**PLANNED UNIT DEVELOPMENT,
SUBDIVISION &
SIDEWALK WAIVER REQUEST
STAFF REPORT**

Date: March 5, 2015

<u>NAME</u>	Gonzalez-Strength & Associates, Inc.
<u>SUBDIVISION NAME</u>	MAP Mobile Govt, LLC Subdivision, Mobile Addition to
<u>LOCATION</u>	2570 and 2590 Government Boulevard (Northwest corner of Government Boulevard and Kreitner Street)
<u>CITY COUNCIL DISTRICT</u>	District 5
<u>PRESENT ZONING</u>	B-3, Community Business District
<u>AREA OF PROPERTY</u>	3 Lots / 13.3 ± Acres
<u>CONTEMPLATED USE</u>	Planned Unit Development Approval to allow multiple buildings on a single building site, and shared access between multiple building lots, Subdivision approval to create 3 lots, and Sidewalk Waiver approval to waive construction of sidewalks along Government Boulevard.
<u>TIME SCHEDULE</u>	Construction to begin April 2015, with opening of store by November 2015.
<u>ENGINEERING COMMENTS</u>

SITE PLAN

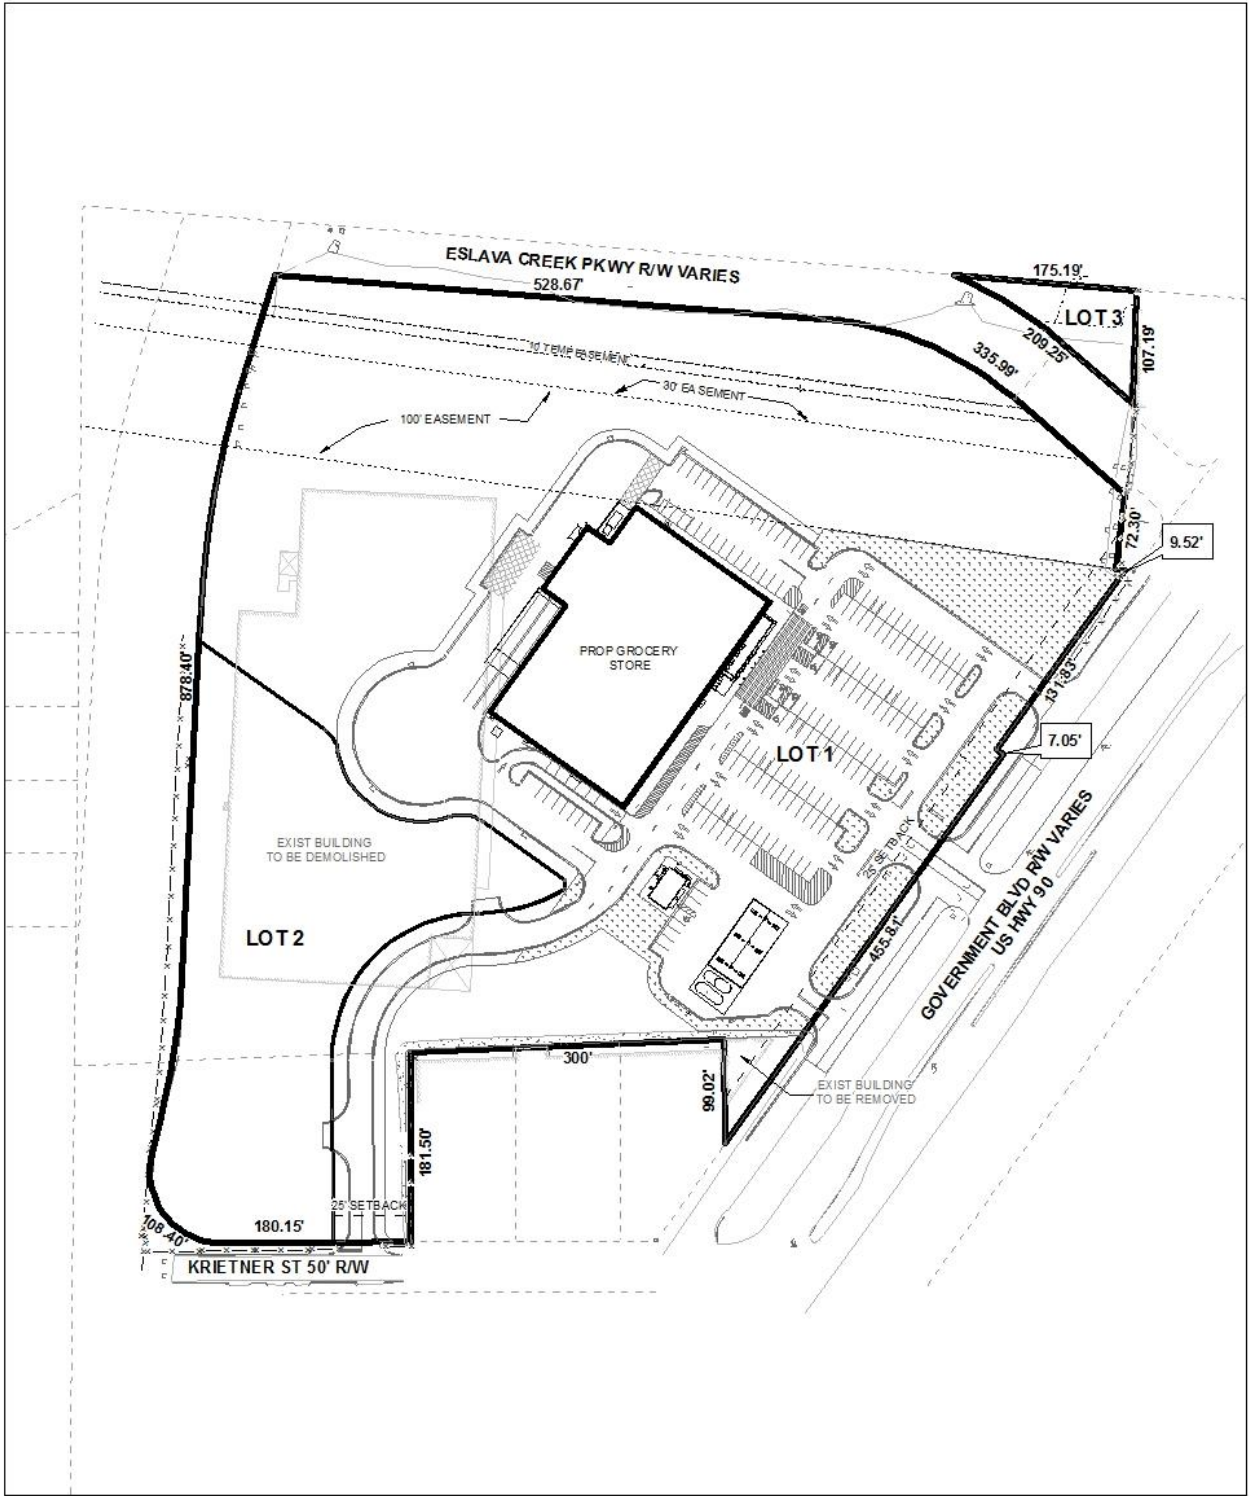
A dumpster pad is indicated on the site plan. All new dumpster facilities must comply with the enclosure and sanitary sewer connection requirements of Section 64-4.D.9. of the Zoning Ordinance.

The 25-foot minimum building setback line, shown on both the preliminary plat and the PUD site plan, should be revised to reflect any required dedication of right-of-way.

Several utility easements cross the site. A note should be placed on the site plan and final plat stating that no permanent structures may be constructed in any easement.

- 1) Revision of the site plan to reflect dedication of right-of-way sufficient to provide 125 feet from the centerline of Government Boulevard;
- 2) Revision of the 25-foot minimum building setback line to reflect any required dedication;
- 3) Revision of the lot size information to reflect any required dedication;

- 4) Placement of a note on the site plan stating that Lot 1 is limited to three curb-cuts to the Government Boulevard right-of-way, that Lots 1 and 2 are limited to one shared curb-cut to Kreitner Street, and that all lots are denied access to any unimproved public rights-of-way;

- 5) Placement of a note on the site plan stating that the size, design and location of any new curb-cuts are to be approved by Traffic Engineering, and ALDOT as appropriate, and comply with AASHTO standards;

- 6) Placement of a note on the site plan stating that development of Lot 3 is denied until such time as frontage on a public or private road is provided;

- 7) Placement of a note on the site plan stating that no structures shall be placed within any easements;
- 8) Full compliance with the Traffic Engineering comments (*Government Boulevard and the adjacent Service Road are ALDOT maintained roadways. If a traffic impact study was completed as a requirement for ALDOT approval, please forward a copy of the study to the City Traffic Engineer for the project file. Lot 1 is limited to three curb cuts to the Service Road, with size, location and design to be approved by ALDOT and Traffic Engineering and conform to AASHTO standards. Access to Kreitner Street is limited to one shared curb cut for Lot 1 and Lot 2, with size, location and design to be approved by Traffic Engineering and conform to AASHTO standards. All on-site parking, including ADA handicap spaces, shall meet the minimum standards as defined in Section 64-6 of the City's Zoning Ordinance.*);

- 14) All new lighting on the site must comply with Sections 64-4.A.2., 64-6.A.3.c. and 64-6.A.8. of the Zoning Ordinance;
- 15) Provision of a revised PUD site plan prior to the signing of the Final Plat;

TYPICAL STREET FRONTAGE CROSS SECTION A-A

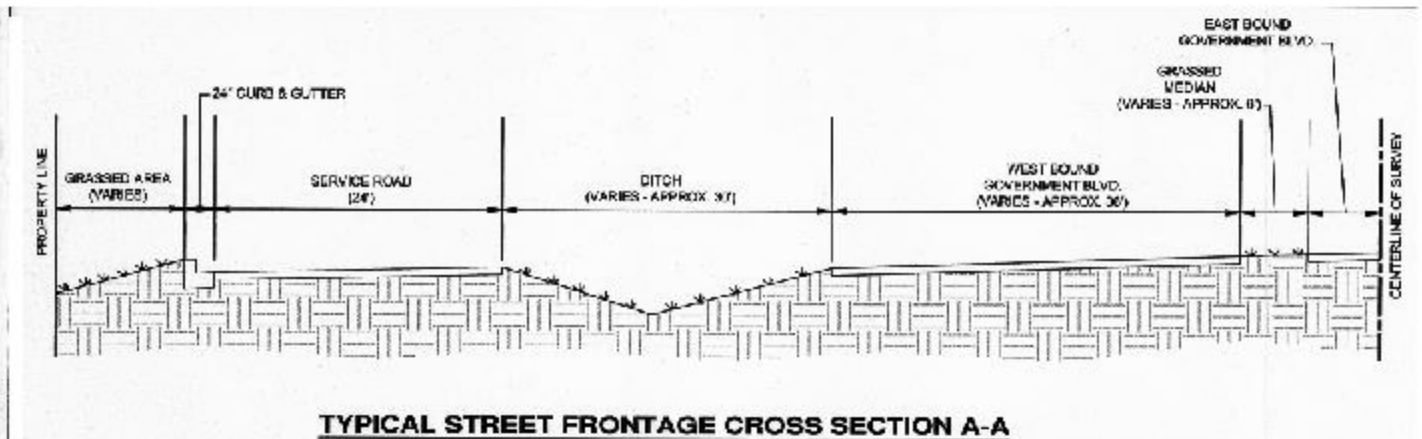
Finally, the applicant is requesting the waiver of the sidewalk requirements for Government Boulevard. The applicant's justification for the sidewalk waiver request is that there are "*No existing sidewalks in the ROW to the north or south of the property.*" No physical impairment to construction was given as a justification for the request. Aerials do show that the nearest sidewalk on the same side of Government Boulevard is located approximately 750 feet to the Southwest of the site. Approximately 900 feet to the Northeast, past the bridge over Eslava Creek (which lacks pedestrian facilities) is the next sidewalk.

While there may not be existing sidewalks in close proximity, the proposed grocery store may attract pedestrians from nearby businesses, including the adjacent motel and the Greyhound Bus Terminal across Government Boulevard. Furthermore, a WAVE bus route serves this segment of Government Boulevard, and may bring some customers and possibly employees to the site.

It should be pointed out that the Mobile City Council adopted a "complete streets" policy on May 31, 2011. The purpose of the complete streets policy is to support the design and construction of streets to enable safe access to all users, including pedestrians, bicyclists, transit riders, motorists, commercial and emergency vehicles, and for people of all ages and abilities. A waiver of the sidewalk, as requested, will limit accessibility for pedestrians, transit riders and cyclists.

Sidewalk Waiver: The request is recommended for Denial.
